Response to Department of Planning Comments

Key Issue 1
GFA and building height exceedances

Updated B1 roof plan showing reduced extent of plant on the southern wing.

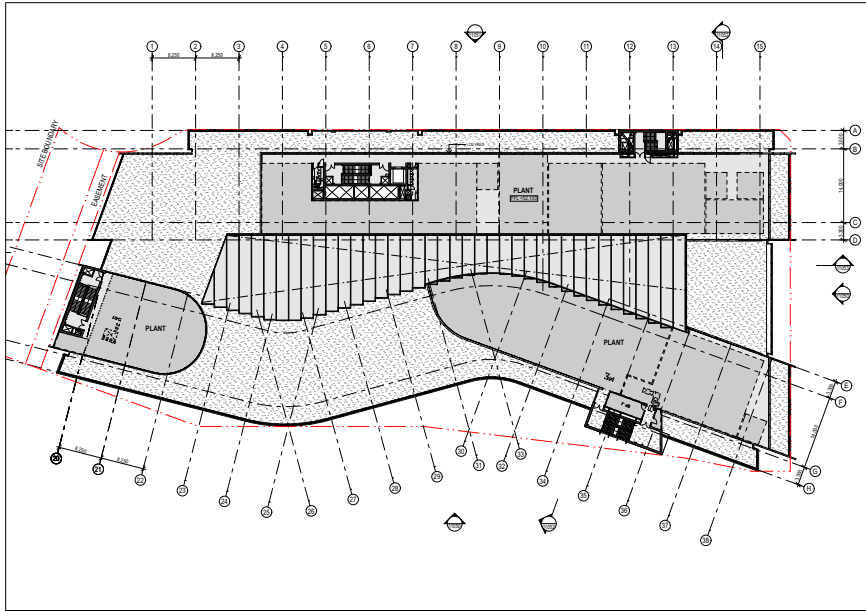
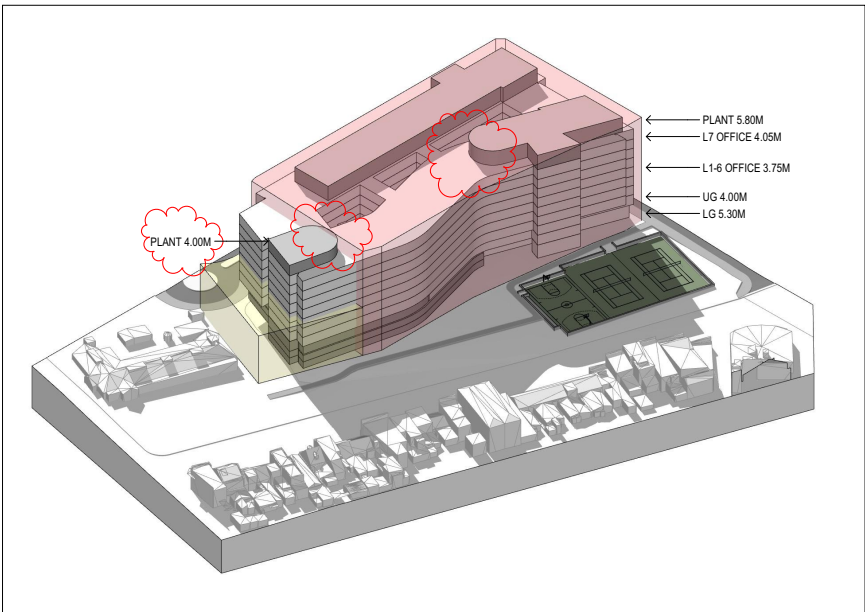
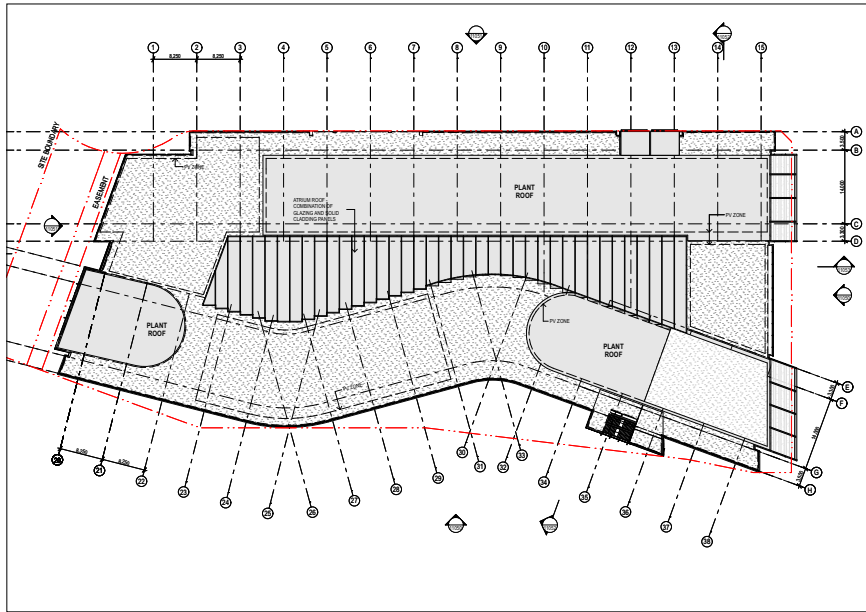
- further justification is required to support the rooftop plant proposed on building 1 and 2, including the function of the plant, and consideration should be given to rationalising the extent of rooftop plant and relocating any necessary plant so as not to adversely impact on the visual quality of the building and overshadowing impacts on neighbouring properties.

- *The extent and height of the B1 plantrooms has been reduced relative to the original SSDA submission. Through redesign, 330sqm of roof top plant has been removed from B1. Through relocation of taller elements of plant to other areas the roof top area of plant associated with the south west core has been reduced in height from 5.8m to 4.0m. This reduction in roof plant reduces the extent of overshadowing to Henderson Road and provides additional solar access to the Henderson Road residences. The remaining areas of roof top plant as allocated to the roof of Building 1 and 2 are essential and have functional requirements to be located on the roof.*
